# **Report on Consultation – Alignment Options**

## **Melgarve Cluster**

**June 2023**

**REF: LT218, LT287, LT419**

**Title:** Figure 2 - Proposed Alignment

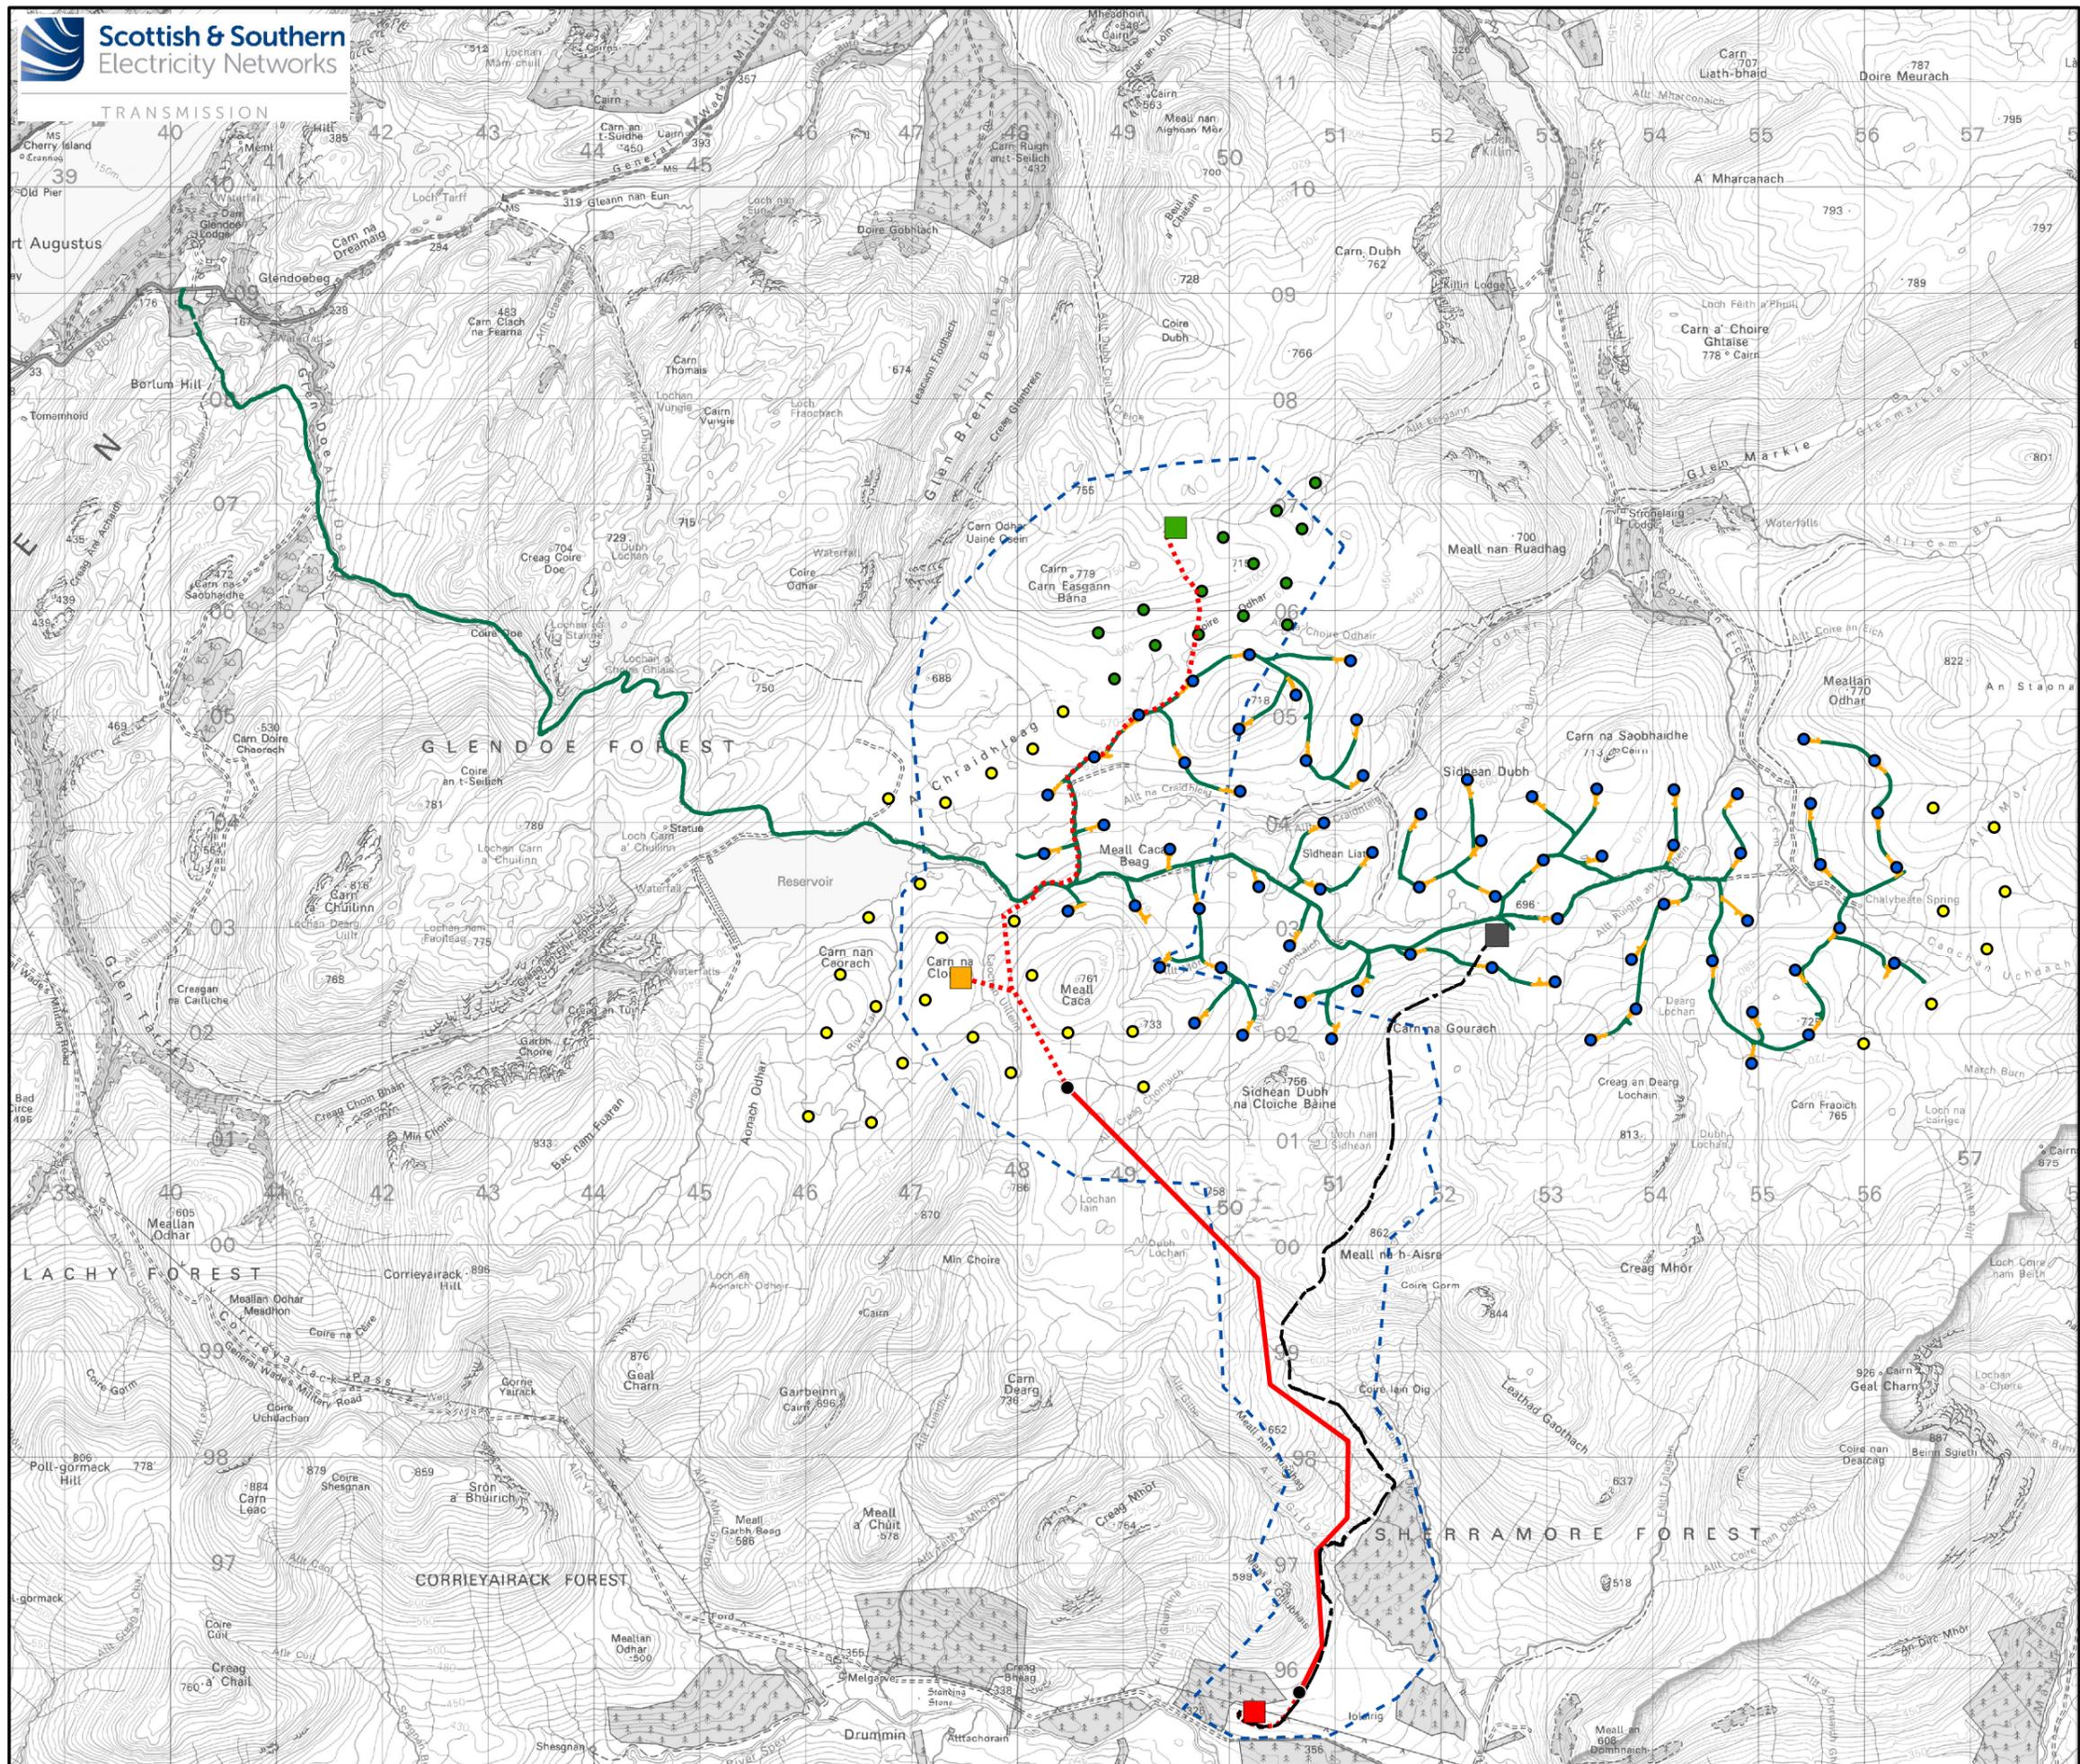
- 6.1.2 SSEN Transmission has concluded from this review that the preferred alignment and design solution set out within the Melgarve Cluster Alignment Options Consultation Document<sup>1</sup> should be taken forward as the proposed alignment and design solution, subject to some minor alterations with respect to the proposed locations of cable sealing end compounds and the indicative UGC alignment. The proposed alignment and design solution can be seen in **Figure 2**.

Title: Figure 1 - Preferred Alignment with Surrounding Existing and Proposed Wind Farms

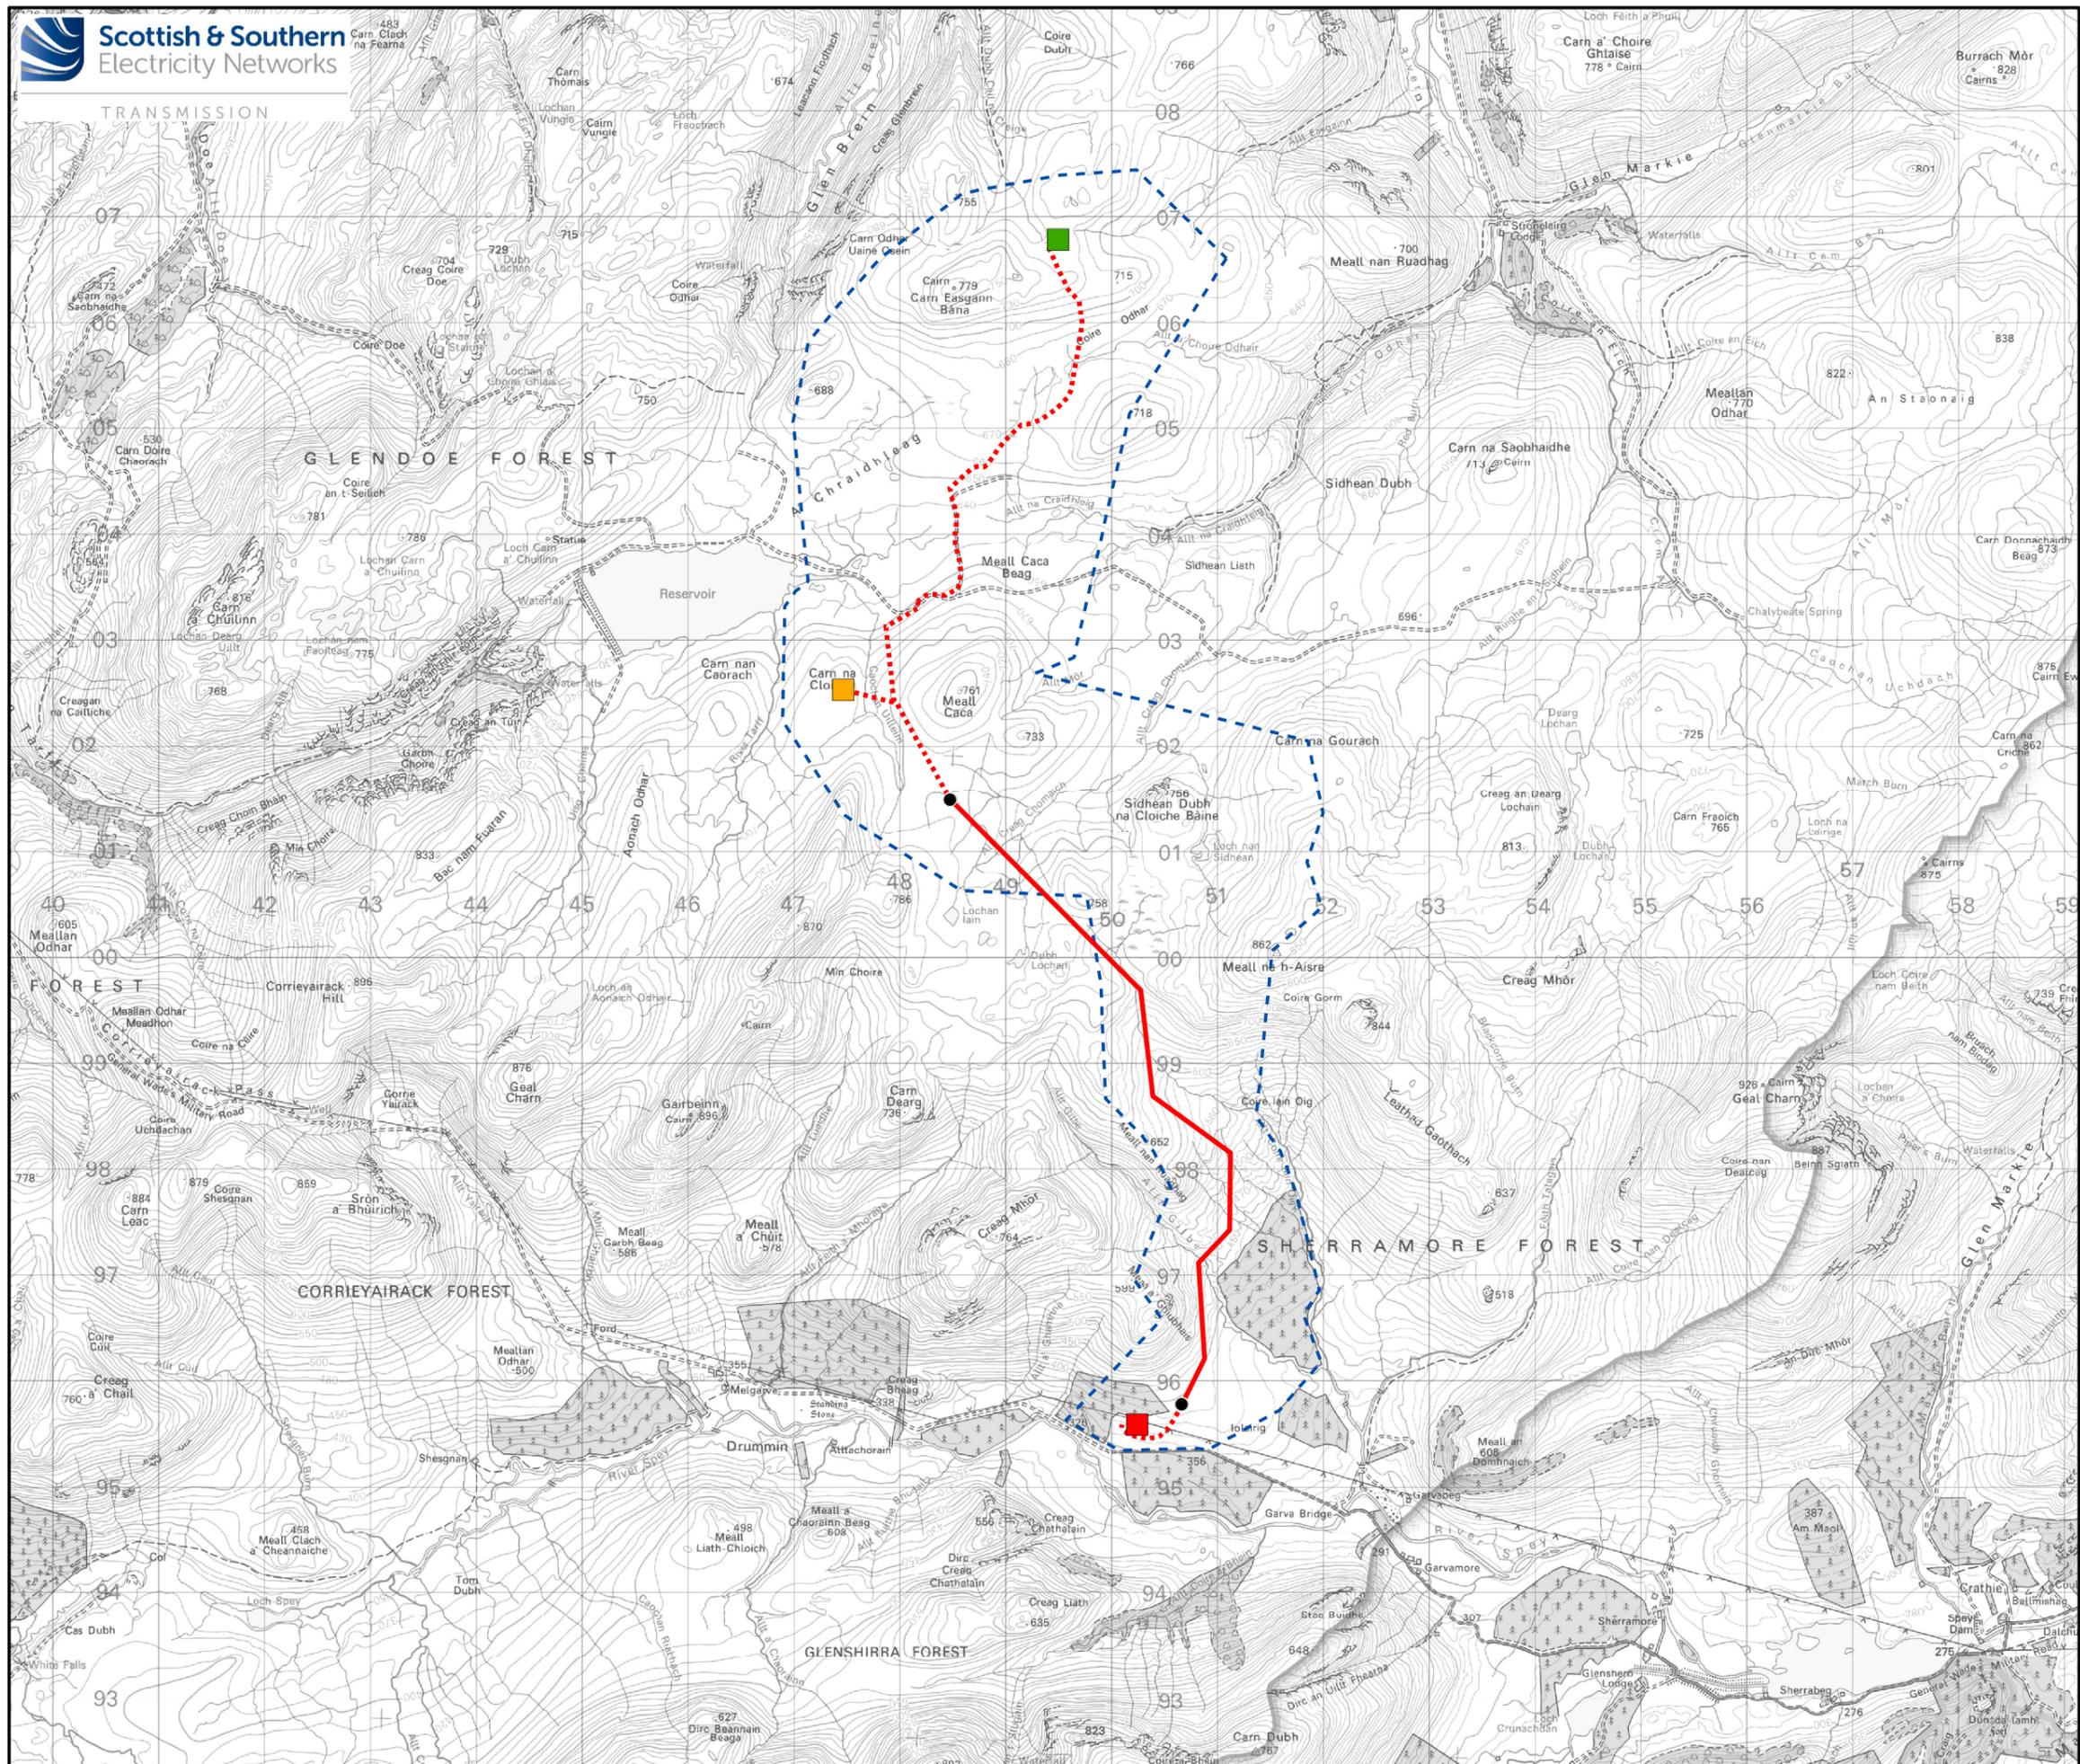
3.2.1 The preferred alignment and design solution was selected on the basis that it is considered to provide an optimum balance of environmental, technical, and economic factors. The preferred alignment and design solution presented within the Consultation Document<sup>1</sup> is shown on **Figure 1**.
